**DEPARTMENT OF THE NAVY**

5090  
Ser N465/1197  
5 Nov 15

Subj: REPLY TO OCNMS LETTER FOR THE NAVY'S NORTHWEST TRAINING AND  
TESTING CONSULTATION

## NMFS-Navy Technical Response

Figure 1. Presence of killer whale ecotypes at site QC from January 2011 – April 2014 (top) (Rice et al. 2015)

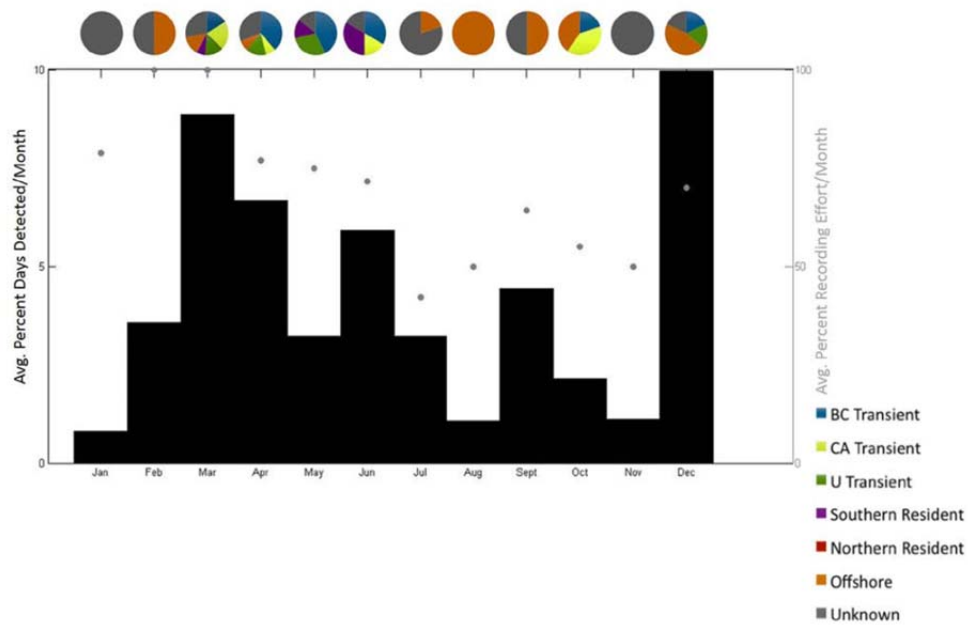
Navy Response. The Navy would caution drawing conclusions about "hot spots" and assumptions of importance based on limited and focused studies without review of the best available science. Mere detection of an animal within an area is not an indication that the animal preferentially uses the area. The Navy is familiar with the studies referred to in this paragraph. Most were conducted under Navy funding. These studies mainly suggest the occurrence or use of an area by some species, not high concentrations or specific biological activities that would lead to biologically meaningful impacts. Additionally, using data from single Navy funded passive acoustic monitoring device is inappropriate to determine if one particular ocean area is more important than another, when in fact beaked whales and other species are likely to occur at multiple locations on the shelf, along slopes, in canyons, and offshore at various times of the year depending on species.

More complete visual or passive acoustic coverage at other U.S West Coast locations would likely document just as much occurrence of beaked whales as those locations in and outside of the sanctuary. Nor is the important concept of residence time discussed. Reviewing the Navy funded passive acoustic monitoring reports confirms the presence of three species of beaked whales, but in looking at the time series of detections, there were not a lot of detections (as compared to other Navy studied sites), and several species showed patterns of seasonal occurrence. The Navy funded work cited in Hanson et al. 2015 for Southern Resident killer whales should also be viewed in the context of the animal's overall movement, which for Southern Residents is very coastally focused. As would be expected for a species focused on salmon prey, highest concentration of Southern Residents is associated with the Columbia River mouth and Westport, with declining occurrence further onto the shelf, including Quinault Canyon. This of course does not preclude short-term occurrence of any species, including Southern Residents in closer proximity to the Quinault Canyon. Since 2004, Navy funded passive acoustic monitoring, which includes killer whale detections, have consistently shown a higher killer whale detection/occurrence at a shelf site within OCNMS vice at an off shelf site at the head of Quinault Canyon (Rice et al. 2015). Rice et al. (2015) documented for the period January 2011-April 2014 only three days (one in March, May, and June) of Resident killer whale detections at the Quinault Canyon site (Figure 1).
